**HISTORIC PRESERVATION COMMISSION STAFF REPORT**

<b>Address:</b>	18 Montgomery Ave., Takoma Park	<b>Meeting Date:</b>	02/08/17
<b>Resource:</b>	Non-Contributing Resource <b>Takoma Park Historic District</b>	<b>Report Date:</b>	02/01/17
<b>Applicant:</b>	Julian Mulvey	<b>Public Notice:</b>	01/25/17
<b>Review:</b>	HAWP	<b>Tax Credit:</b>	n/a
<b>Case Number:</b>	37/03-17H	<b>Staff:</b>	Dan Bruechert

**PROPOSAL:** Solar panel installation

Description: 2 panels, east side of front of house

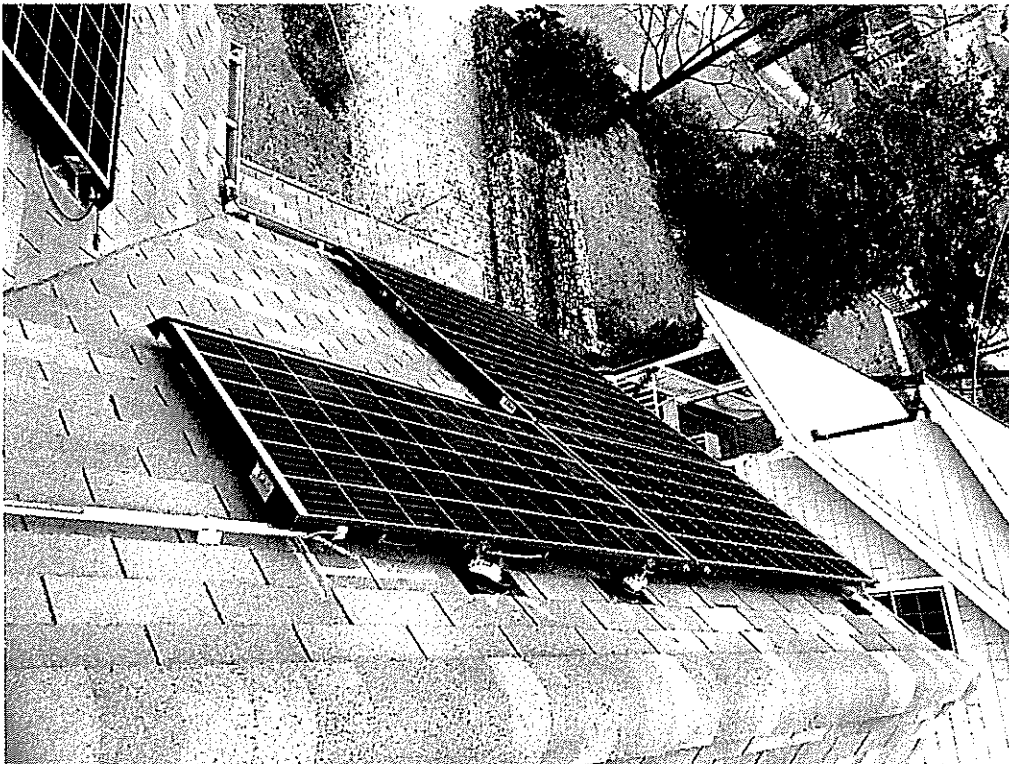
- The 4 south facing panels on the gable-L roof (fig. 3),
- The 2 west facing panels on the front-facing gable (fig. 3, and
- The front 6 panels on the east-facing side of the front-facing gable (fig. 1)

are not approved and directs the applicant to remove these panels

Description: 4 panels, front of house, greatest visibility

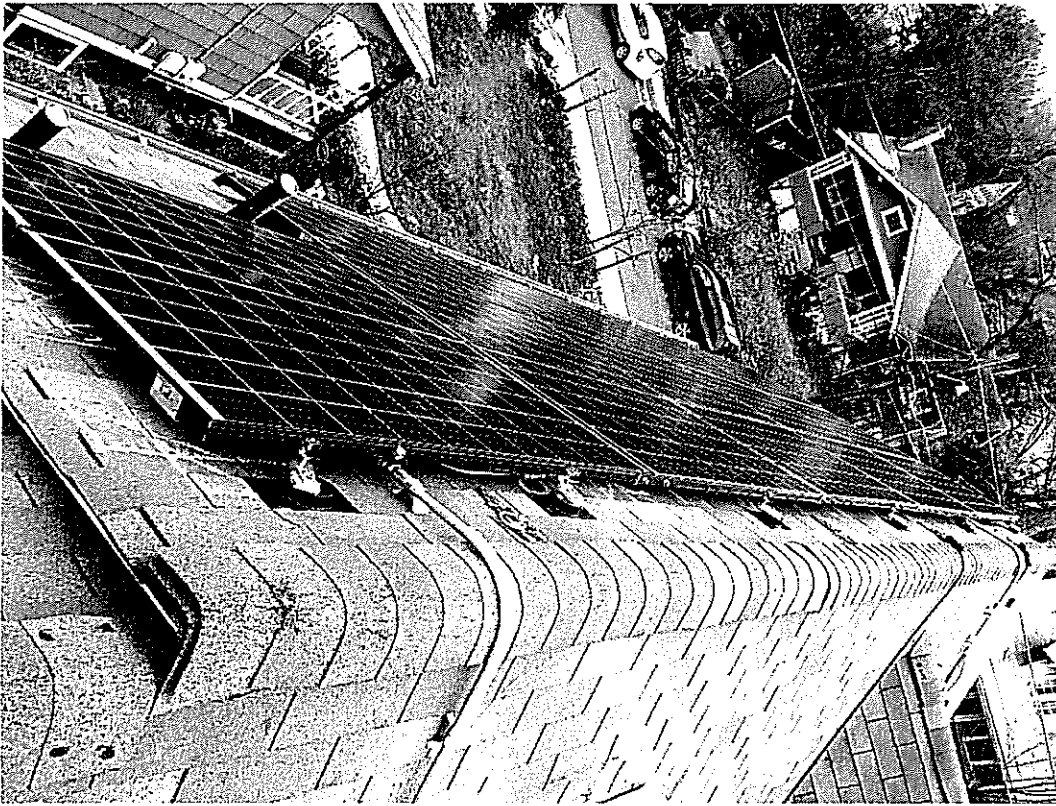
- Fifteen of the proposed solar panels (described below) would be located in readily visible locations that alter the perceived massing of the resource and would have a detrimental effect on the surrounding streetscape and could impair the character of the district as a whole due to their visibility and incompatibility.
